# EL CENTRO COLUMBIA CITY

## EL CENTRO DE LA RAZA

3818 S ANGELINE ST  
SEATTLE, WA 98118  
DESIGN REVIEW  
SDCI PROJECT #3038450-LU

8.0 ITEMIZED RESPONSE TO EDG

Figure 1.4: Plan showing entry court, building manager's office, courtyard, and surrounding spaces providing supervision.

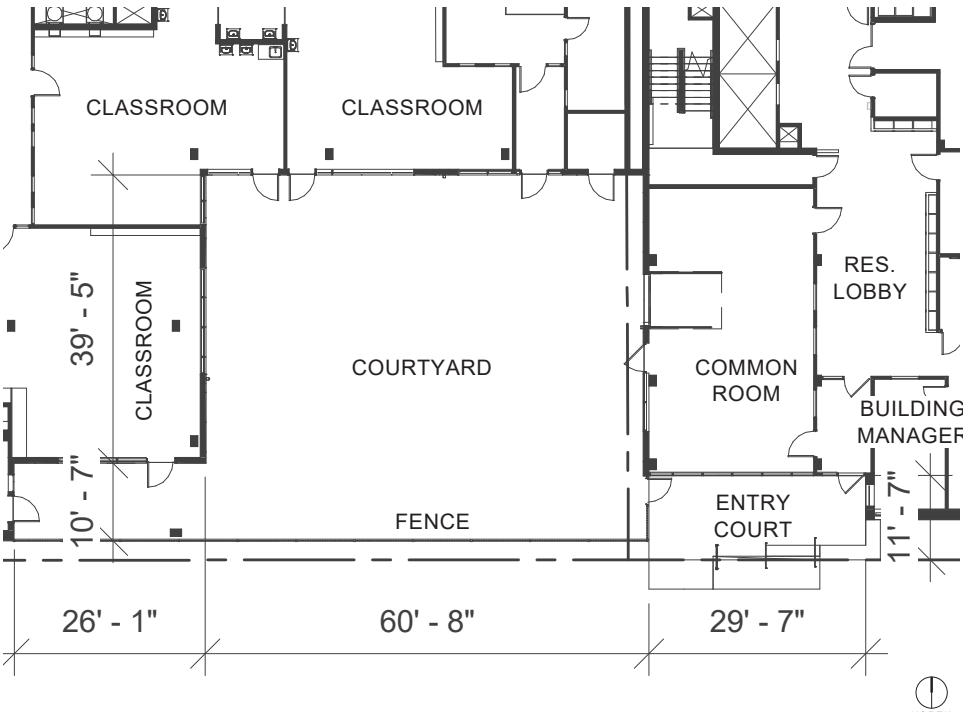
- Residential and Child Development Center entries have been refined to include a deep entry court adjacent to the building manager office, which will help separate and define the two entrances, while also allowing for close supervision of this area by building staff.
- The play area will also be secured with a 6' tall fence and access-controlled gate during program hours. During off hours, the play area will be accessible through the exterior gate and the common room through the residential entry.

Figure 1.5: Plan showing detailing of parking lot

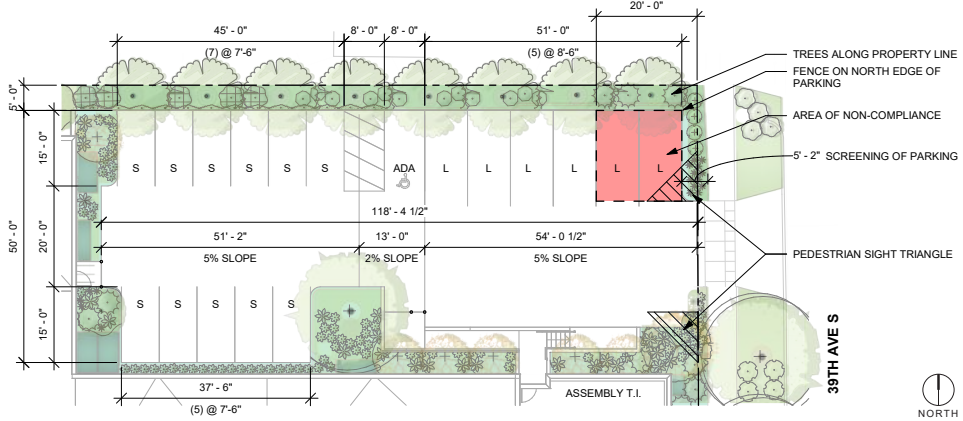
- Many design alternatives were explored, though the design team maintains that any scheme which eliminates parking stalls within 20' of 39th Ave S property line result in less parking for the project, which was of primary concern to the neighborhood.
- Landscaping, fencing and signage have been integrated to minimize this impact to the residential neighborhood. It also greatly improves the current condition of the existing surface parking lot.
- See Departure Request 9.

Figure 2.1: Plan showing courtyard space and points of ingress, all individually controlled for access by building staff.

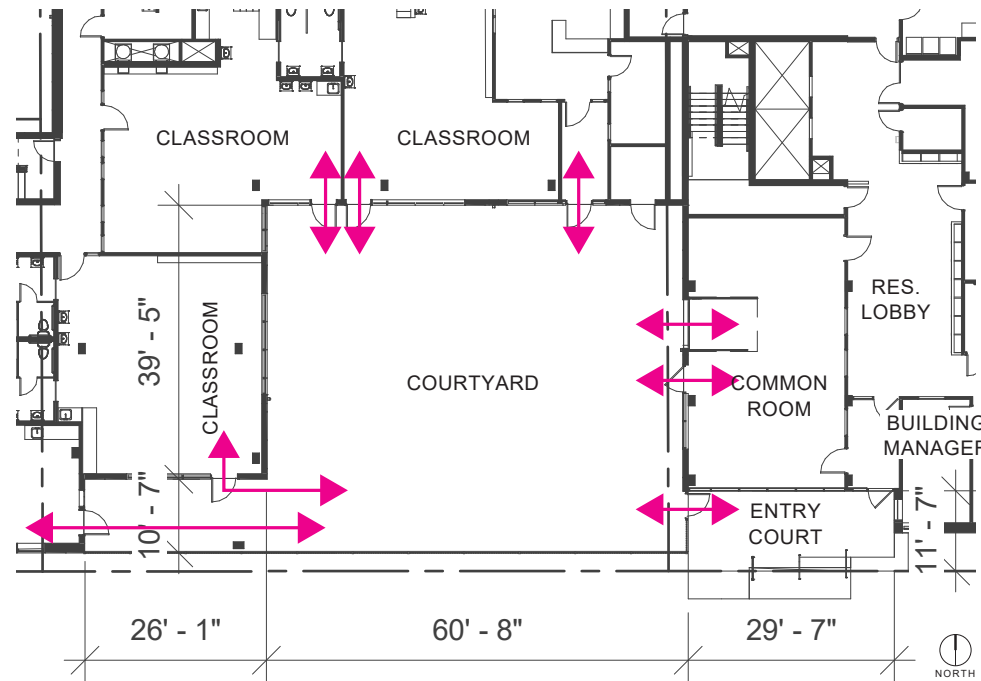
- Access to the play area will be controlled by Child Development Center staff during hours of Center operations. In addition to the main entry, each classroom has independent access to the play space to allow for maximum flexibility of play space access. [Figure 2.1]

Figure 2.2: N-S section showing relationship of residential units to north property line.

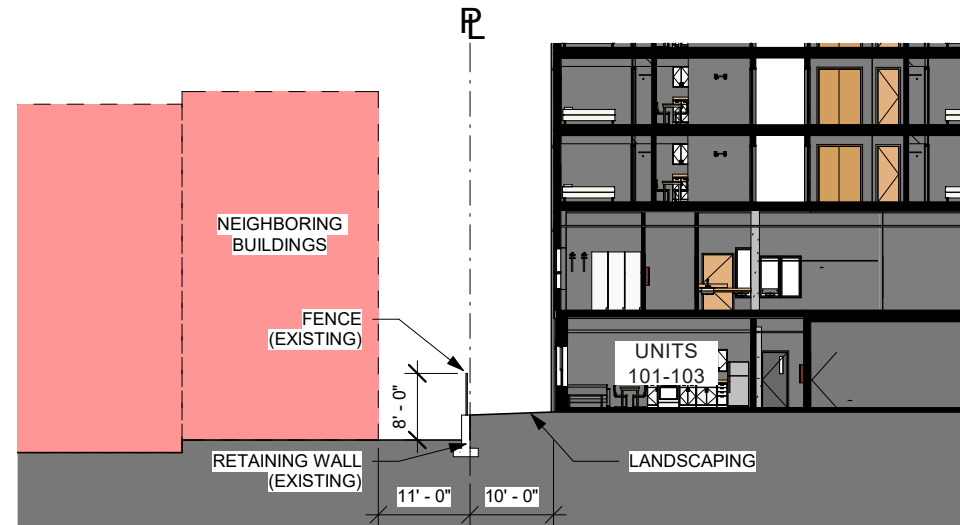
- The project design team includes an acoustic consultant which has helped ensure acoustic separation between living units & trash room & parking areas. Owing to the construction type, window emergency egress is not required for these units. Light and air will be similar to other north-facing units above, given that these units are sitting above grade, have the same setback as above, and the site slopes down to the north. Additionally, native and shade-loving landscaping will enhance views from these rooms and increase privacy. [Figures 2.2-2.3]

Figure 3.1: Site plan showing activity throughout site and eyes on the street. Dropoff and mail accommodations are also highlighted

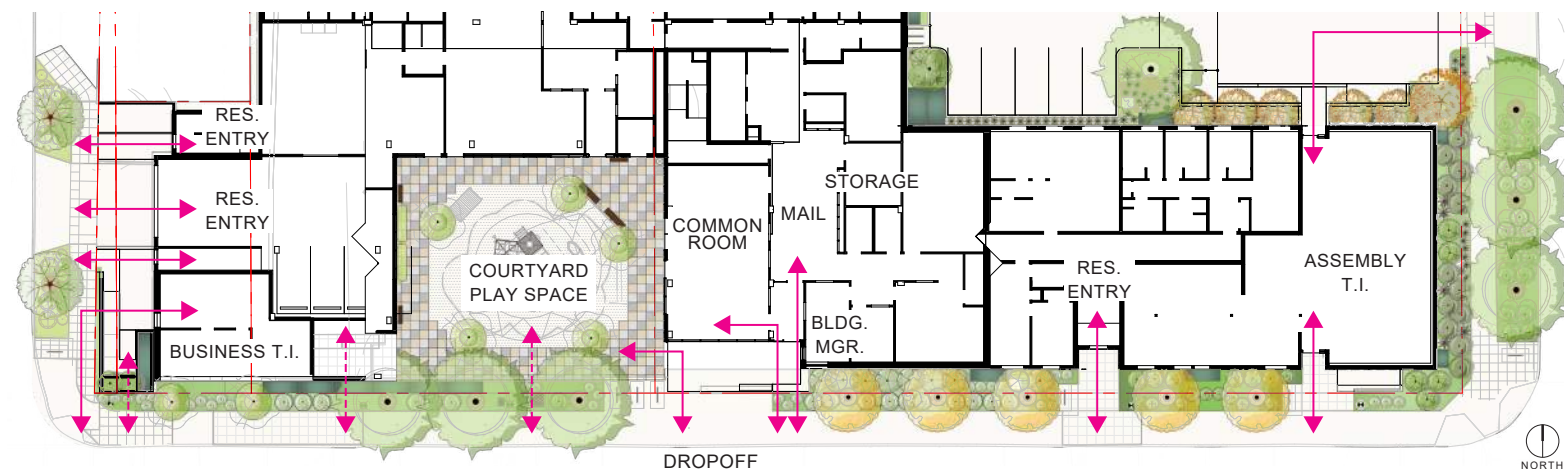
- See response to 1d, 2b, & 2c. The residential and Child Development Center entry area has been revised as a covered court which helps identify points of ingress with the addition of wayfinding signage. The location of the building manager adjacent to this space will help ensure security and eyes on the street at this location.
- The Assembly and Business T.I.s are on opposite ends of the building. The entrances throughout the entire site create activity and presence which will give a higher level of safety. Exterior lighting will also enhance safety. [Figure 3.1]

- Mail & deliveries will be delivered to mail area and adjacent Storage room. Drop-off will occur on South Angeline adjacent to main entrance. This will be coordinated with SDOT. [Figure 3.1]

Figure 3.2: Plan showing child development center and residential entry court.

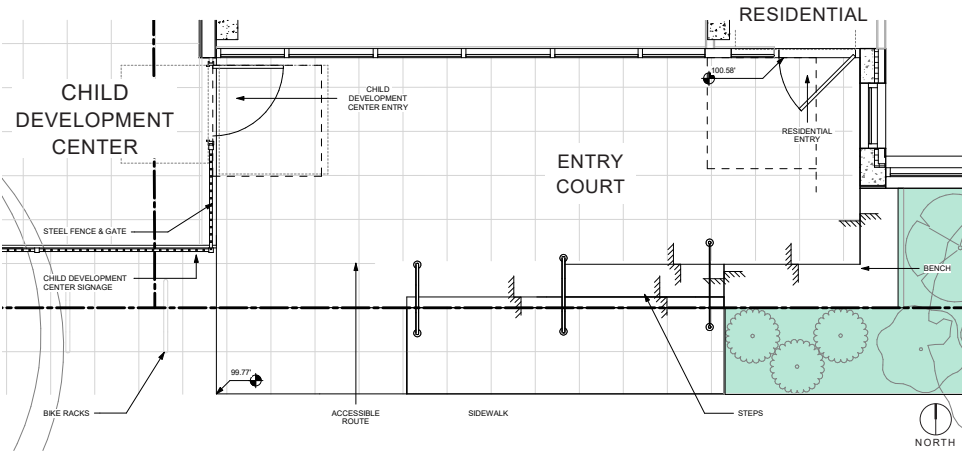
- The Child Development Center and Residential entries will both be from an entry court which provides weather protection and staff supervision. Tile mural will also adorn this space, and help guide pedestrians coming from the east into the space. [Figure 3.2]

Figure 3.4: Civil site plan showing below grade parking entry.

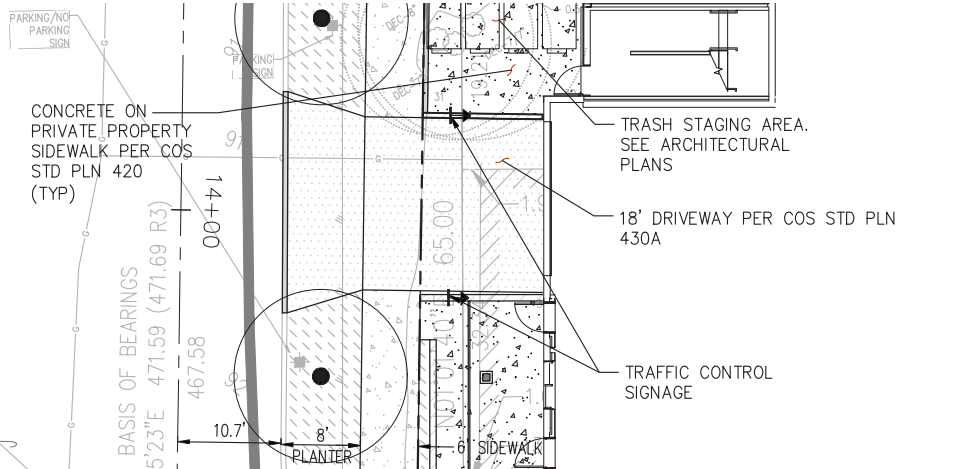
- The partially below-grade parking entry located off 38th Ave. S will be controlled with an overhead garage door, and will include signage and transparent site elements to maintain necessary sight triangles. [Figure 3.4]

Figure 3.5: Site plan showing locations of short-term bike parking

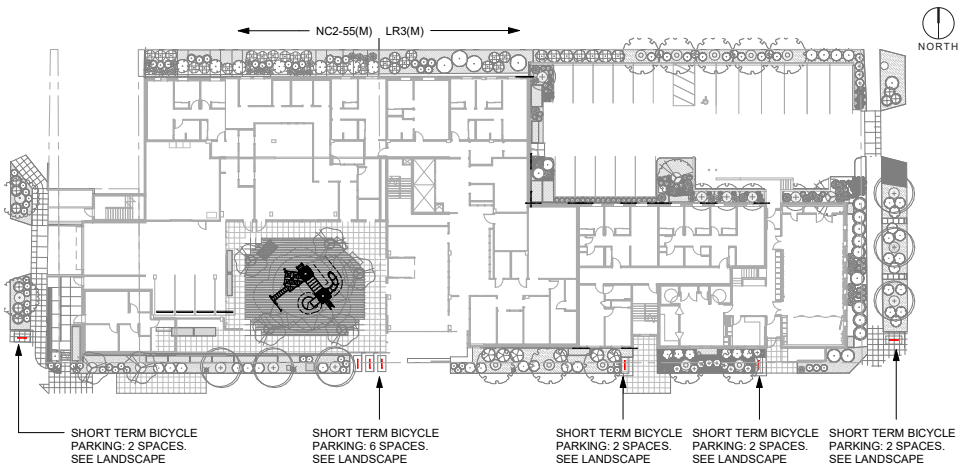
- Short-term bicycle parking will be located across the entire project site, adjacent to each primary building entrance.

Figure 3.6: Signage examples for building, canopy, and wayfinding signage

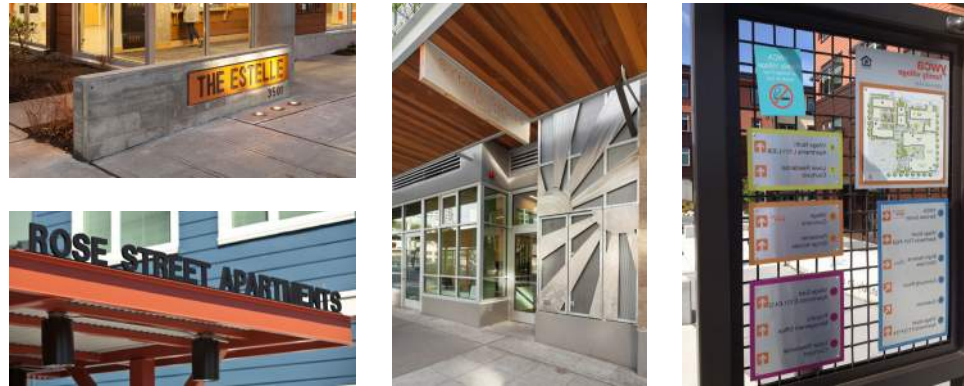
- A signage plan is being developed in collaboration with the owner. Signage will be provided for each use, and wayfinding information for building visitors will be located at the SW, SE and Residential entry locations.

Figure 3.7: Plan showing condition at north property line, including landscaping and neighboring buildings' relationship with the proposed.

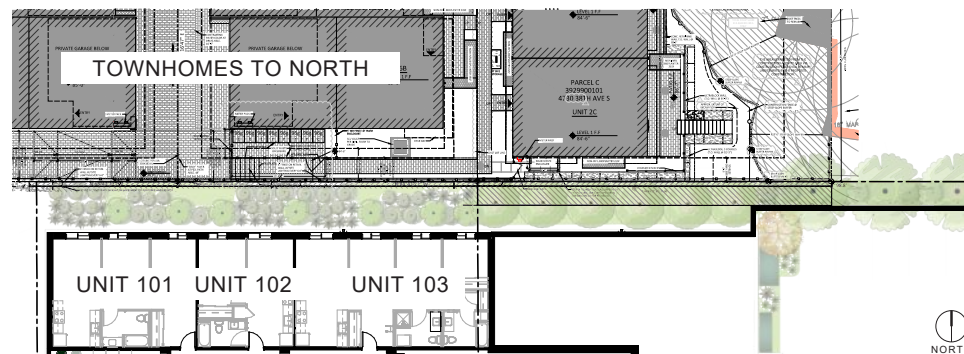
- The project will be graded to meet the existing grades & fence lines of all adjacent projects. Specifically, the level one living units, grade will slope down towards the existing retaining walls and fencing along the adjacent property.
